ARMY ENGINEER DISTRICT NORFOLK VA
NATIONAL DAM SAFETY PROGRAM. LANIER DAM (VA-089100. ROANOKE RIV--ETC(U)
JAN 80 B O TARAN

Name Of Dam: LANIER
Location: HENRY COUNTY
Inventory Number: VA. 08910

PHASE I INSPECTION REPORT

NATIONAL DAM SAFETY PROGRAM

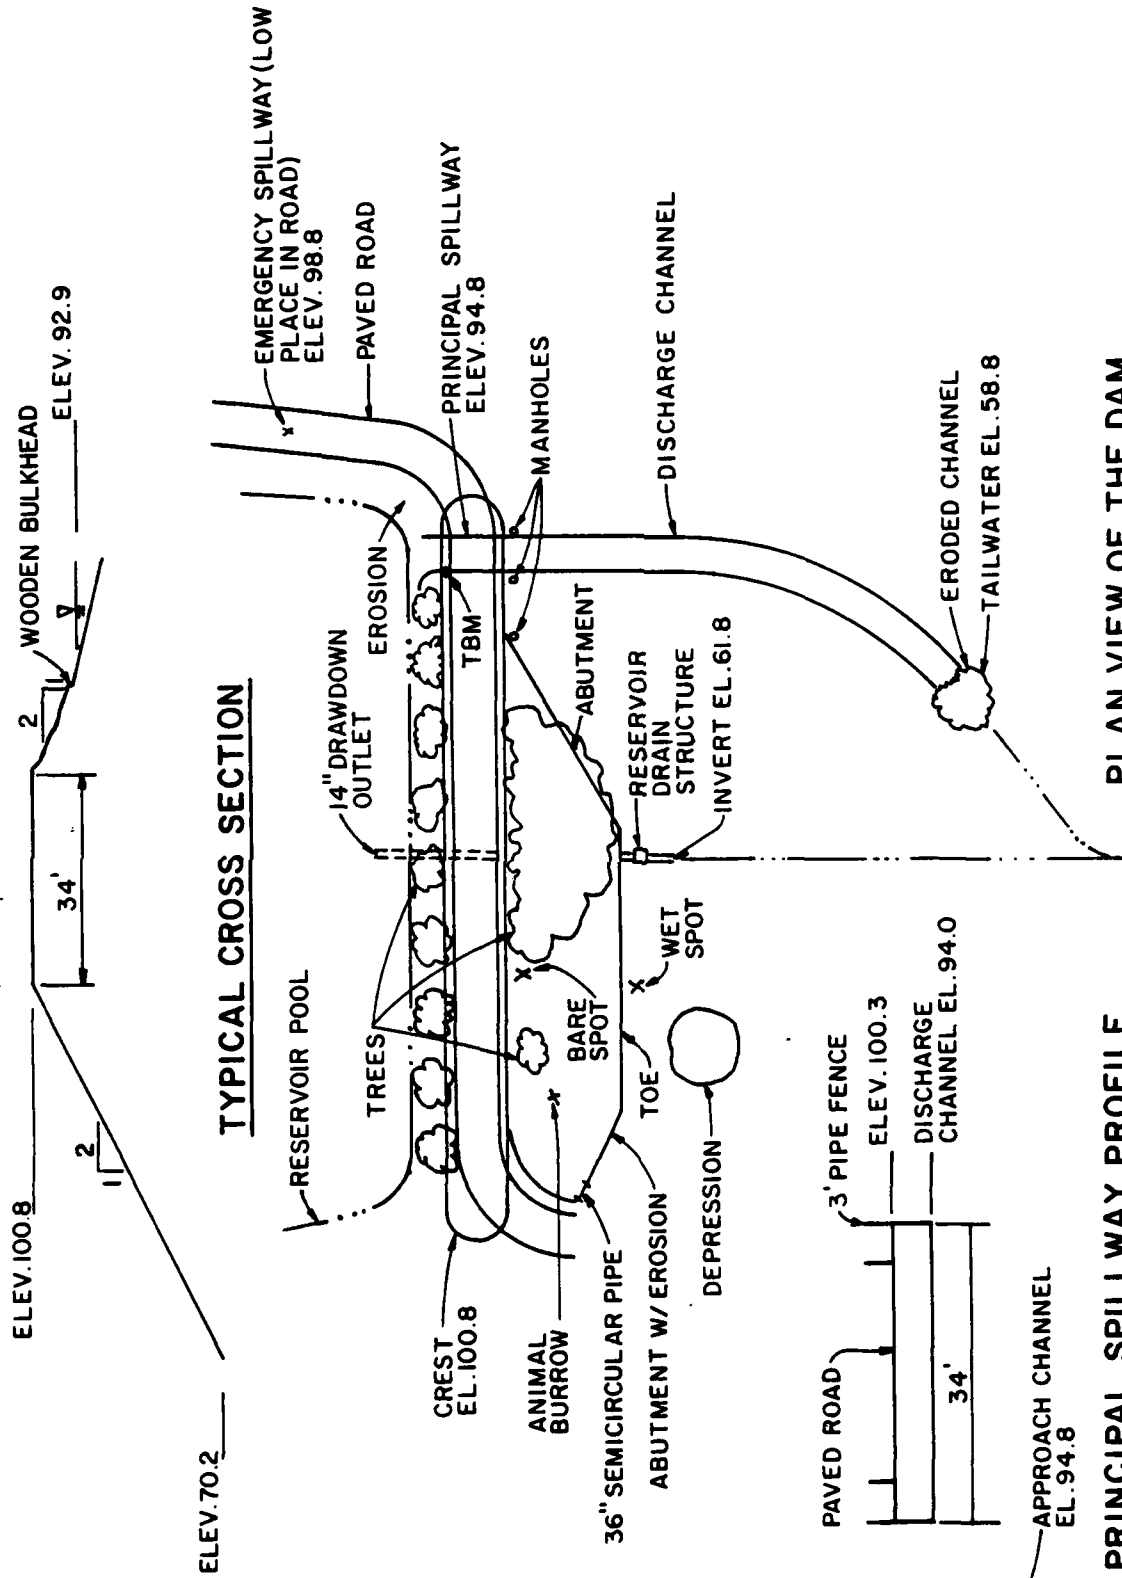
There is a wet spot in the downstream area at the toe of the embankment, a bare spot and an animal burrow on the downstream slope, all as located on Plate II. The wet spot is as shown in Photo 5 and the animal borrow in Photo 4.

d. The bare spot noted on Plate II should be reseeded.

e. The animal burrow, noted in Plate II, should be backfilled with compacted fill and seeded.

f. The wet spot noted on Plate II should be monitored for seepage or boils during a regular maintenance program. Should seepage occur, a professional geotechnical engineer should be consulted.
